SUBJECT: SURRY UNITS 1 AND 2 - ISSUANCE OF AMENDMENTS RE: F DELTA H LIMIT
AND STATISTICAL DNBR METHODOLOGY (TAC NOS. M81271 AND M82168)

AMENDMENT NO. 170 TO FACILITY OPERATING LICENSE NO. DPR-32 - SURRY UNIT 1
AMENDMENT NO. 169 TO FACILITY OPERATING LICENSE NO. DPR-37 - SURRY UNIT 2

SAFETY EVALUATION BY THE OFFICE OF NUCLEAR REACTOR REGULATION
RELATED TO AMENDMENT NO. 170 TO FACILITY OPERATING LICENSE NO. DPR-32
AND AMENDMENT NO. 169 TO FACILITY OPERATING LICENSE NO. DPR-37
VIRGINIA ELECTRIC AND POWER COMPANY
SURRY POWER STATION, UNIT NOS. 1 AND 2
DOCKET NOS. 50-280 AND 50-281

TS FIGURE 2.1-1

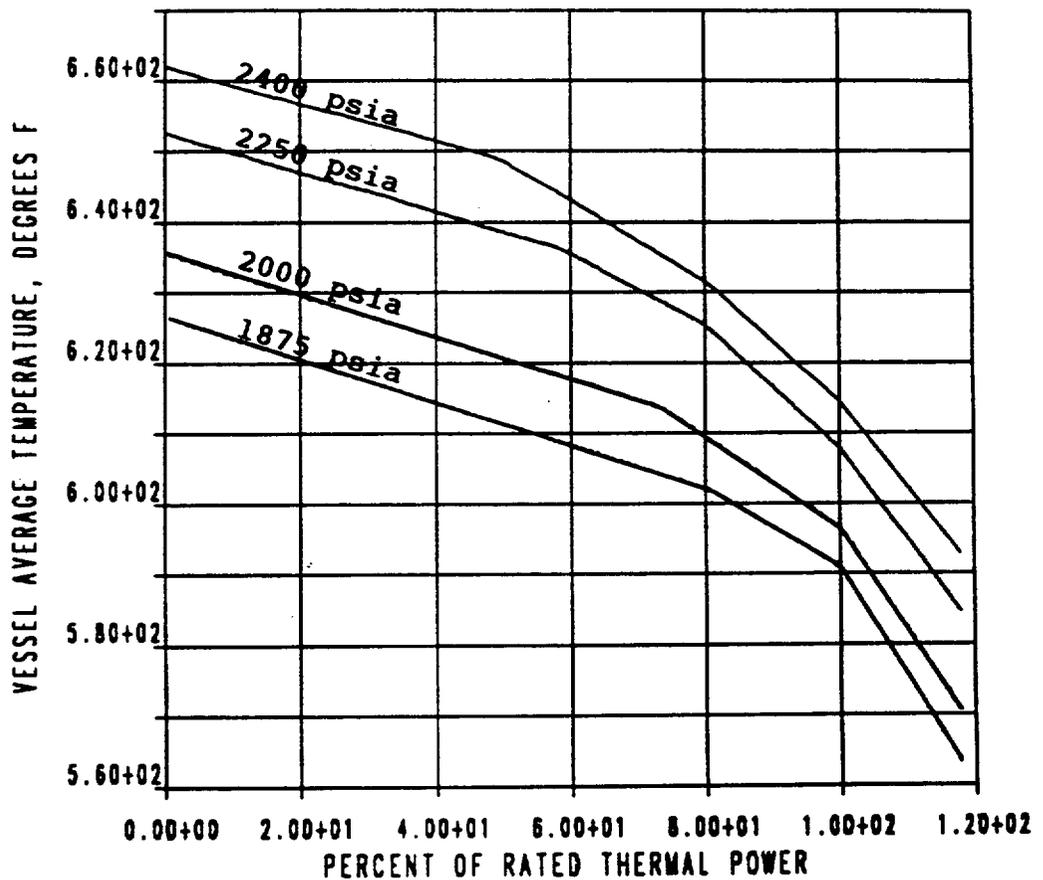
- d. TS Figure 2.1-1 - change to reactor core thermal and hydraulic safety limits to reflect 1.62 F-delta-h.
- e. TS 3.12-3 - change to equation for F(N)-delta-h to reflect F-delta-h surveillance limit; change in line referring to above equation; change to F-delta-h surveillance limit value in discussion of maintenance operation within hot channel factor limits.

TS Figure 2.1-1 is based on an $F\Delta H(N)$ of 1.62, a 1.55 cosine axial flux shape, and a deterministic DNB analysis procedure including margin to accommodate rod bowing⁽¹⁾. TS Figure 2.1-1 is also bounding for a statistical treatment of key DNBR analysis parameter uncertainties including an enthalpy rise hot channel factor which follows the following functional form: $F\Delta H(N) = 1.56 [1 + 0.3(1-P)]$ where P is the fraction of rated power. TS Figures 2.1-2 and 2.1-3 are based on an $F\Delta H(N)$ of 1.55, a deterministic treatment of key DNB analysis parameter uncertainties, and include a 0.2 rather than 0.3 part power multiplier for the enthalpy rise hot channel factor.

TS FIGURE 3.12-8

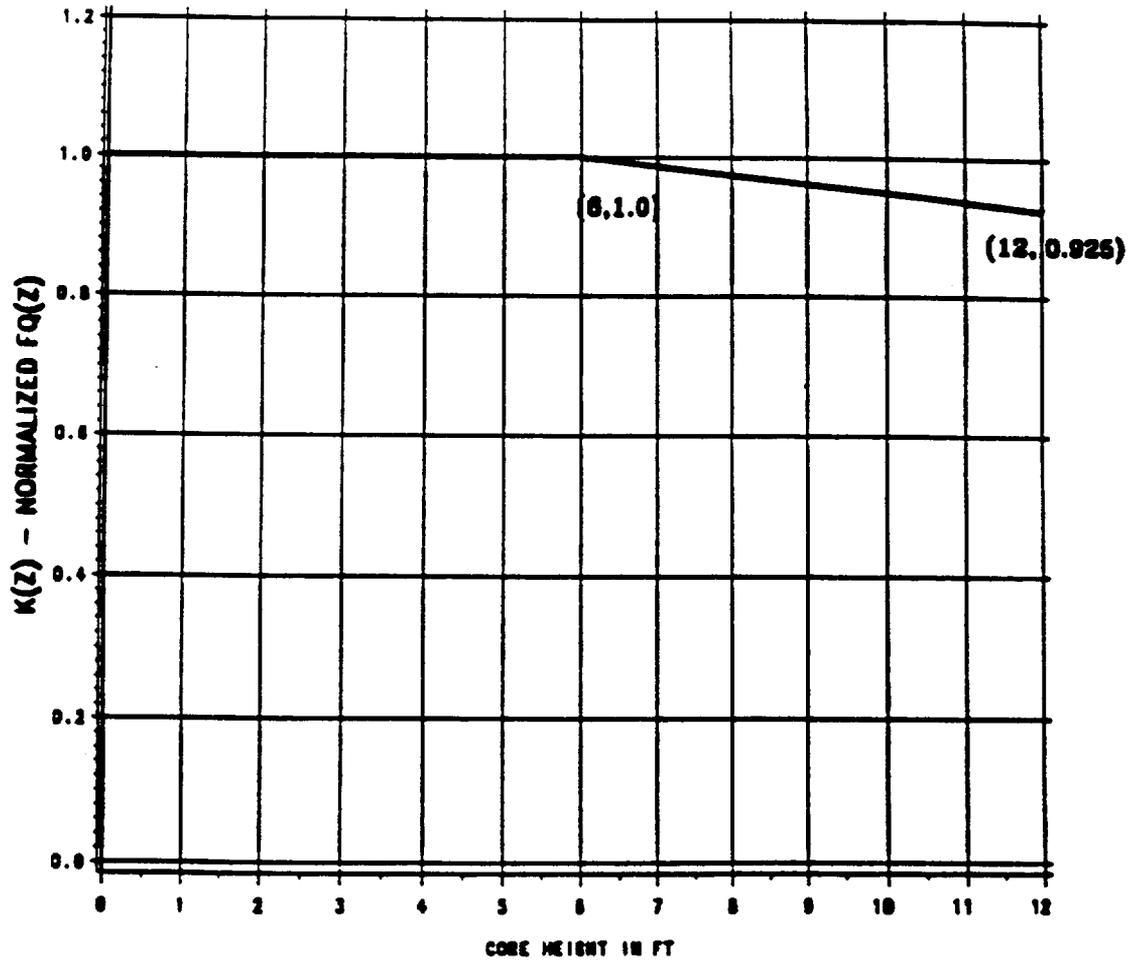
- k. TS 3.12-19 - Bases discussion is added for DNB parameters specified on TS pages 3.12-11 and 3.12-11a.
- l. TS Figure 3.12-8 - change to hot channel factor normalized operating envelope, to reflect changed F-delta-h.
